**In the Drawings**

FIG. 4

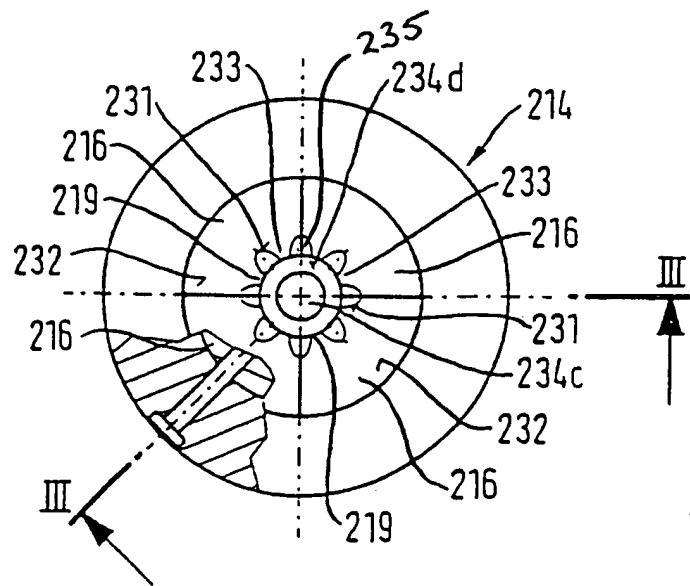
Paragraph 2 of the outstanding Office Action indicates a reference character “220” has been used to designate both nose-like projections and bulge-like projections. Applicant has amended the specification so that “nose-like projections” are identified by number “219.” Specifically, page 12, second paragraph, lines 22 and 26 have been amended by deleting 220 in favor of 219. Figure 4 identifies the nose-like projections as number 219.

Paragraph 3 of the outstanding Office Action indicates that the drawings are objected to for failing to comply with 37 CFR § 1.84(p)(5) because the reference signs found in Figure 4, “219” are not mentioned in the description. Applicant respectfully submits that this objection is overcome by the amendments stated in the paragraph above. No new matter has been added to the application pursuant to this Amendment.

Applicant respectfully submits reference sign 221 is shown in Figure 1 as originally submitted and identifies a circular cylindrical space defined by the cylindrical bore 220. Reference sign 235 has been added as a proposed drawing correction to Figure 4 identifying the base 235 of the grooves 231 of the die 214. Applicant respectfully submits that reference sign 262 is shown in Figure 1 as originally submitted identifying the transverse wall perpendicular to the longitudinal axis inside the cylindrical bore 220. Applicant respectfully submits that reference sign 316 is shown in Figure 5B as originally submitted identifying a hold down member of the setting head 300. A proposed drawing correction to Figure 5G is included wherein reference sign 325 has been added identifying the annular ring fold of the sheet metal part. A proposed revision to Figure 6A is included, wherein reference sign 430 has been deleted
